## **Product Change Notification**

#### Product Change Notification: E-20-014475

General Product Description: JPT GEH ASSY 2P

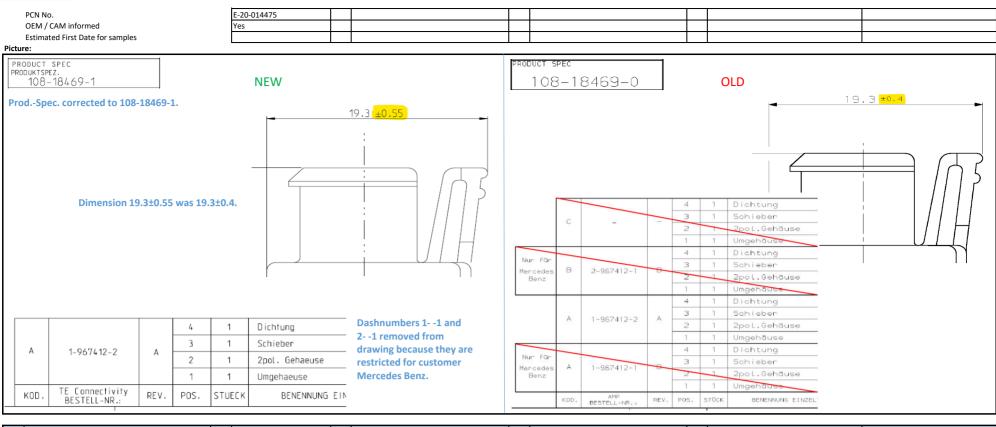
Prod.-Spec. corrected to 108-18469-1; dimension 19.3+/-0.55 was 19.3+/-0.4; dashnumbers 1- -1 and 2- -1 removed from drawing because they are restricted for customer Mercedes Benz

х	Potential Impact for Customer	х	Product Type	х	Change Type	х	Kind of Change	X	Change Feature	Remark / Free text
		х	CONNECTOR HOUSINGS	х	No Form, Fit, Function	х	Drawing	х	Drawing Change	Document Clarification. No part
										change!
										ProdSpec. corrected to 108-
										18469-1. Dimension 19.3±0.55
										was 19.3±0.4. Dashnumbers 11
										and 21 removed from drawing
										because they are restricted for
										customer Mercedes Benz.
